Exploded View of X0101 Faucet

Speedy Faucets Change, Q4 2016.

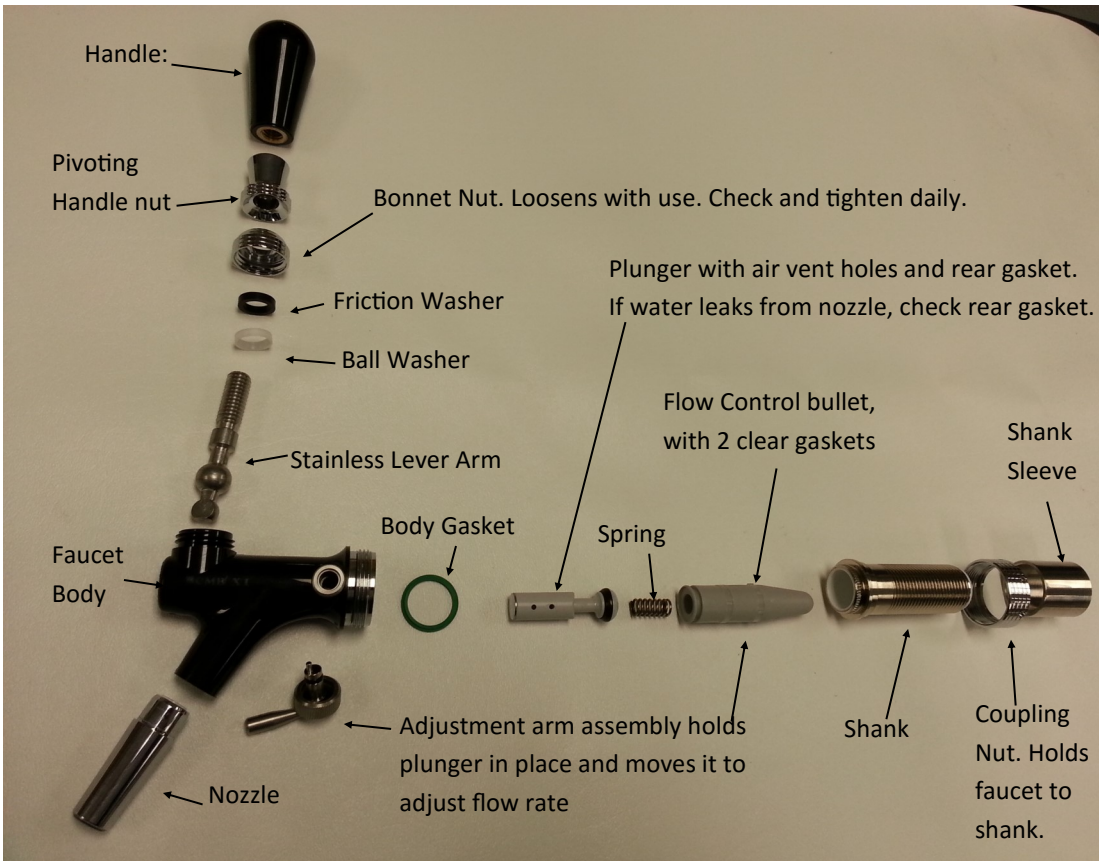
Now standard on all CR-1 & CR-2 countertop model configurations.

Downward pointing bowed nozzle. Also raised position on panel of CT models for more clearance.

Bowed Nozzle, standard flow control:

Part Number: X0101-B

Bowed Nozzle, Hex locking flow control:

Part number: X0101-B-HEX
